1965 Corvette: Service News: Vent the Window Regulator Motor

Subject: Vent the Window Regulator Motor

Model and Year: 1965 - All Chevrolets

Date: December, 1965 - Volume 37 - Number 11

Fig. 1—Installing Window Regulator Motor Lower Attaching Screw (Vented)

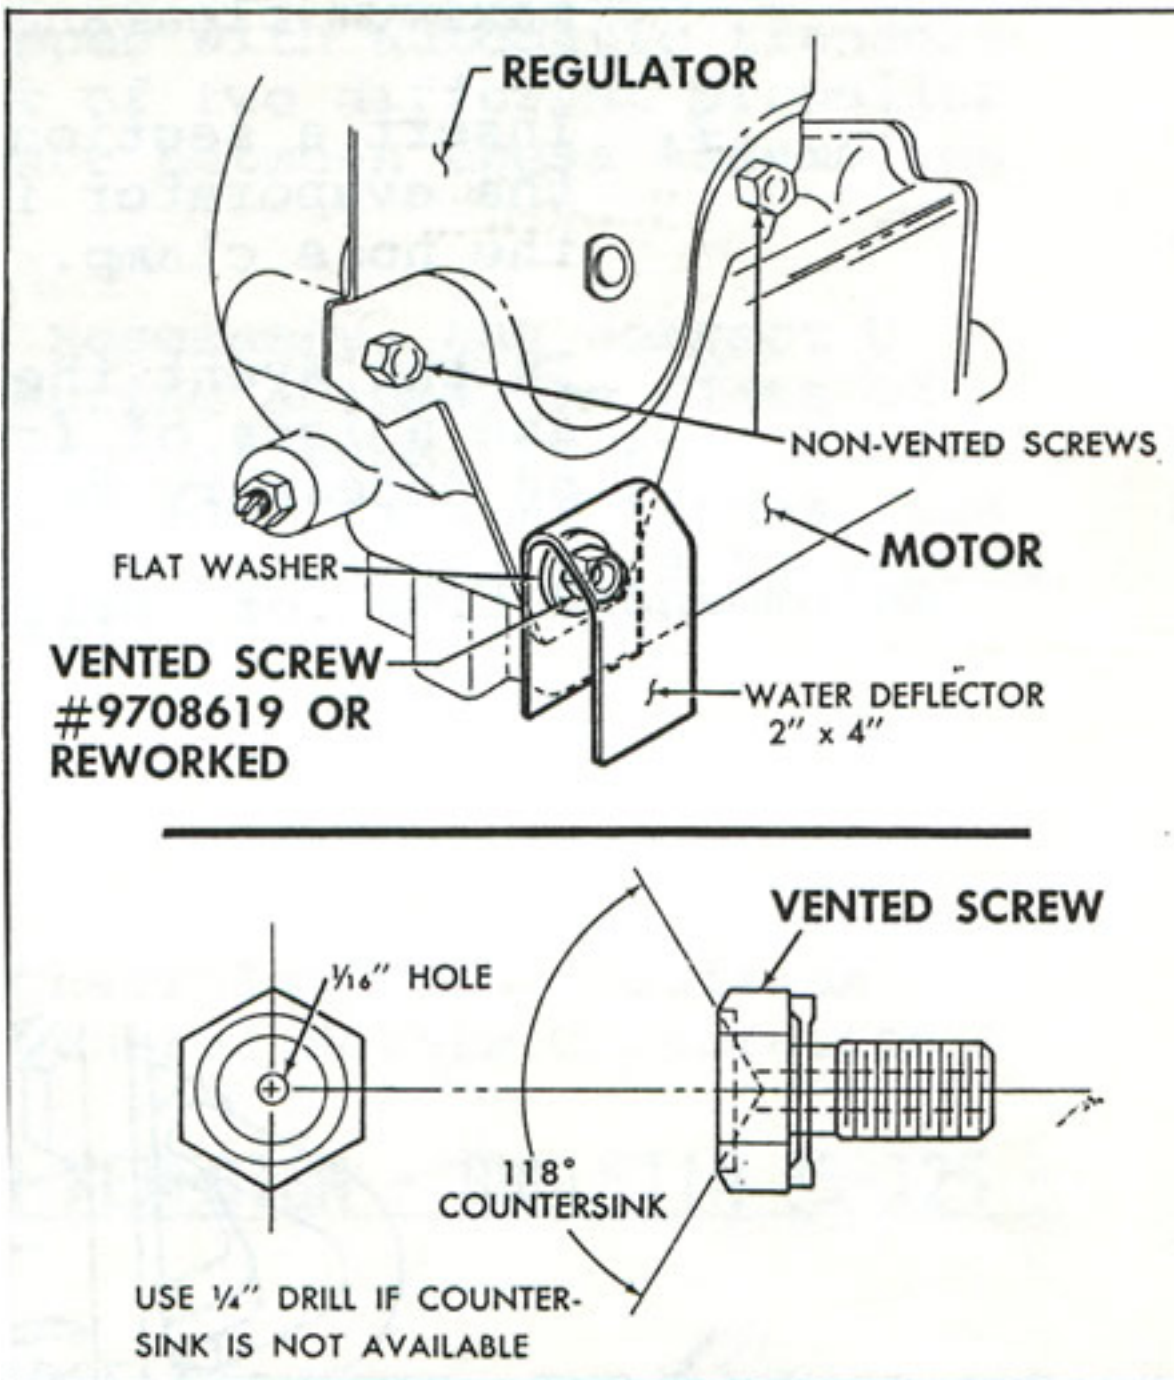
Refer to article "Replacing Window Regulator Motor", on the last page of November issue of Service News for door window regulator motor replacement and before completely replacing the motor, the lower attaching screw should be drilled through (hollow) to vent the motor (See Fig. 1). Venting the motor on all replacement motors will improve the reliability of power window motors.

IMPORTANT: *The screw to be vented is the lower one of the three screws. The motor housing is cored to permit air to enter motor interior only at this one location.*

NOTE: *If vented screw Part No. 9708619 is not available, drill a 1/16" hole through the center of one of the motor to regulator attaching screws and countersink the head of the screw (Refer to Fig. 1). Drill hole starting at threaded end of screw.*

Construct a water deflector, 2" x 4" with a 1/4" hole 1-1/4" from one end, from suitable water repellent material.

A hollow screw #9708619 will become available for service at a later date.

Production now incorporates this change.
